2 SITE CHARACTERISTICS

2.0 North Anna 3 Site

This chapter of the U.S. Nuclear Regulatory Commission's (NRC's) safety evaluation report (SER) provides the NRC staff evaluation of the North Anna 3 Combined License (COL) Final Safety Analysis Report (FSAR) which addresses the geological, seismological, hydrological, and meteorological characteristics of the site and vicinity, in conjunction with present and projected population distributions and land use and site activities and controls.

Figure 2.5.2-10. Comparison of the Applicant's Site Amplification Function with the Results of Staff's Confirmatory Analysis

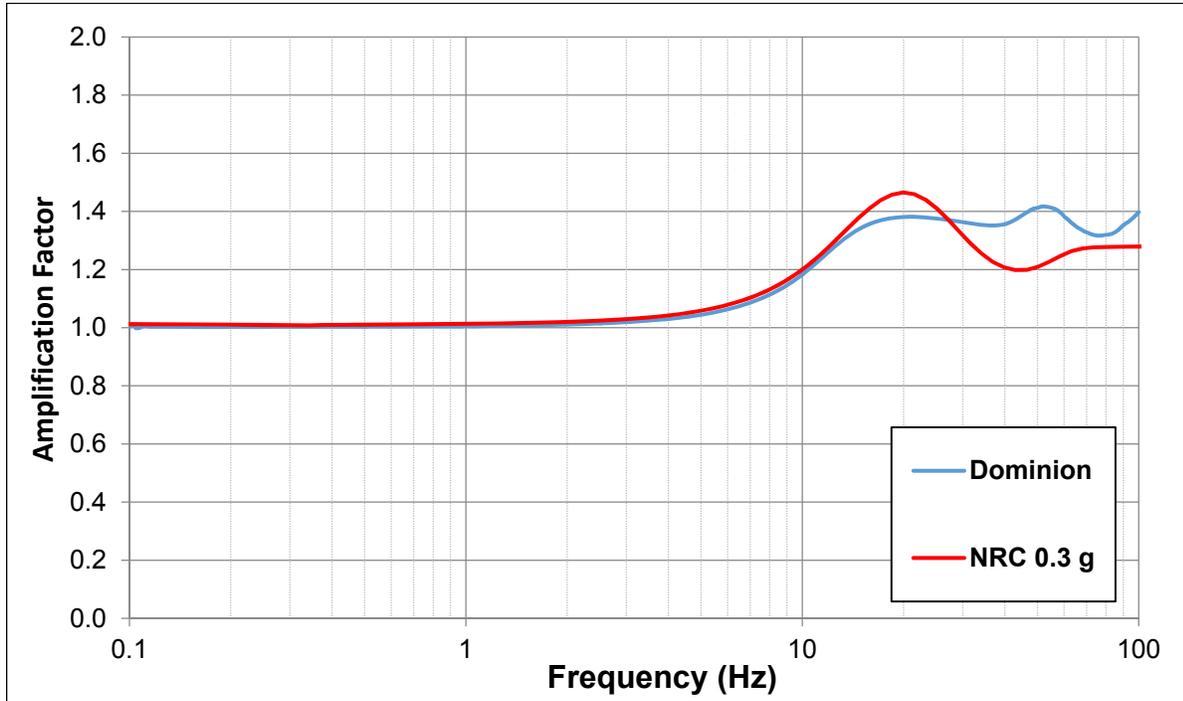
The staff performed a confirmatory analysis of site response using values reported by the applicant for geophysical parameters. The staff independently developed BE velocity profiles, randomized the velocity profile and shear modulus degradation and damping curves and calculated site-specific amplification functions at the GMRS elevation. Figure 2.5.2-10 shows a comparison of amplification functions developed by the staff with those developed by the applicant. The differences in site amplification functions calculated by the staff and the applicant are not significant considering that staff used Approach 3 and the applicant used Approach 2, as described in NUREG/CR-6728, for the site response calculations. The staff subsequently combined its PSHA results at the 10^{-4} and 10^{-5} exceedance frequencies with its amplification functions and calculated a site-specific GMRS. Figure 2.5.2-11 shows a comparison of the site-specific GMRS developed by the staff with that developed by the applicant. The applicant's

Based on the applicant's response to RAIs related to the site response calculations and staff's independent confirmatory analysis that is consistent with the applicant's results, the staff considers RAI 2.5.2-2, RAI 2.5.2-3, and RAI 2.5.2-6 resolved and closed.

Figure 2.5.3-1. LiDAR-derived hillshade map showing locations of key North Anna 3 borings and surface mapped (Mixon et al, 2000) and trench mapped (Dames and Moore, 1973) representations of fault 'a' (from Response to RAI 2.5.1-6d, Figure 1)

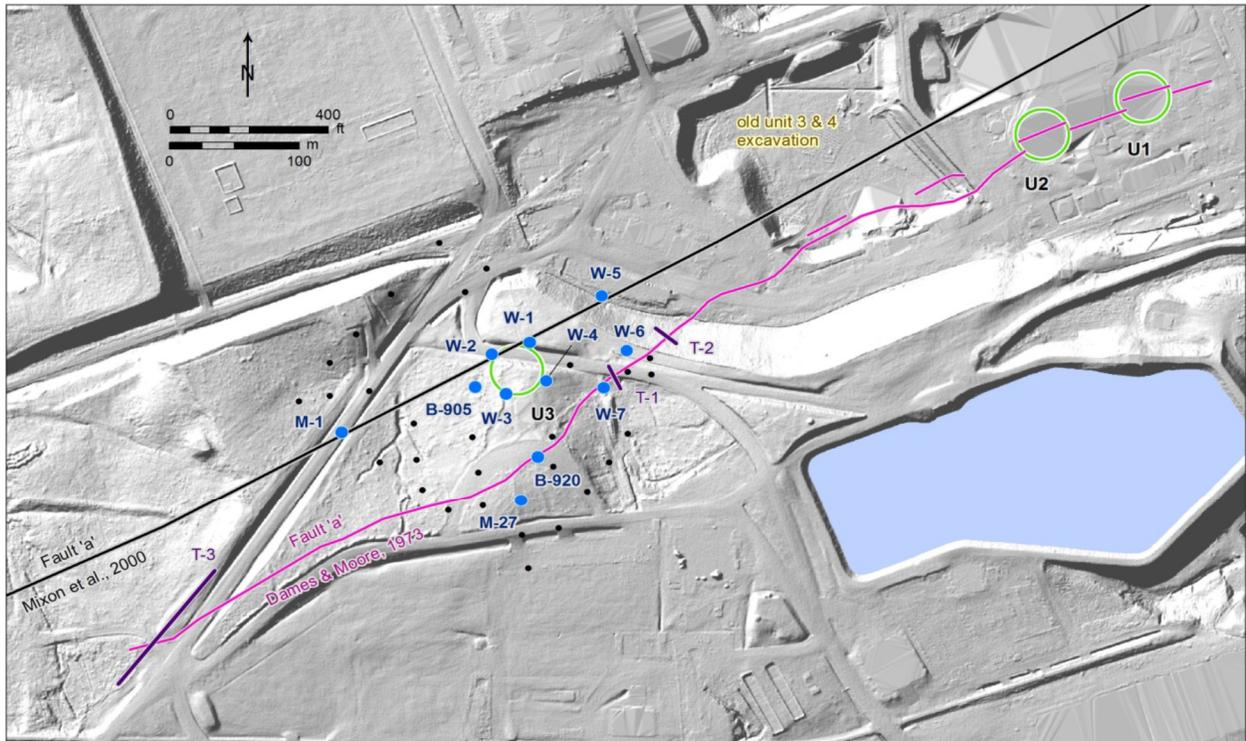
The staff reviewed several Dames and Moore reports from the 1970's regarding fault 'a' (VEPCO, 1974; 1973) in addition to the findings in the ESP SER regarding fault 'a' (NUREG-1835). The shear zone observed in W-1 and W-5 has similar features to fault 'a' but at a much less significant scale. Because the micro-shear zone in W-1 and W-5 is located northwest of fault 'a' and likely also dips northwest, it is structurally higher than fault 'a' (Figure 2.5.3-1 of this report). The staff notes that significant tectonic structures such as fault 'a' typically have a zone of deformation and deformation fabric is not necessarily limited to a single fault plane so the micro-shear zone could be associated with fault 'a'. Regardless of a structural association or not, the deformation associated with fault 'a' was determined to be geologically old, greater than 1 million years old. The staff considers the shear zone in W-1 and W-5 likely to be the same age as fault 'a' and not a potential future surface deformation hazard to the site.

The staff reviewed DCD COL Item 2.0-28-A, which states the ESBWR design requires the applicant to demonstrate that there is no potential for permanent ground deformation at the site area. The staff concludes that the additional information from additional borings in the site area in conjunction with response to RAI 02.05.01-6c, that provides clarification regarding the possibility of finding major shear zones in the borings as opposed to determining specifically Quaternary fault movement, that there is sufficient subsurface information to resolve DCD COL Item 2.0-28-A. Accordingly and in compliance with 10 CFR 100.23 and 10 CFR 52.79, the staff considers RAI 02.05.01-6c resolved and closed.
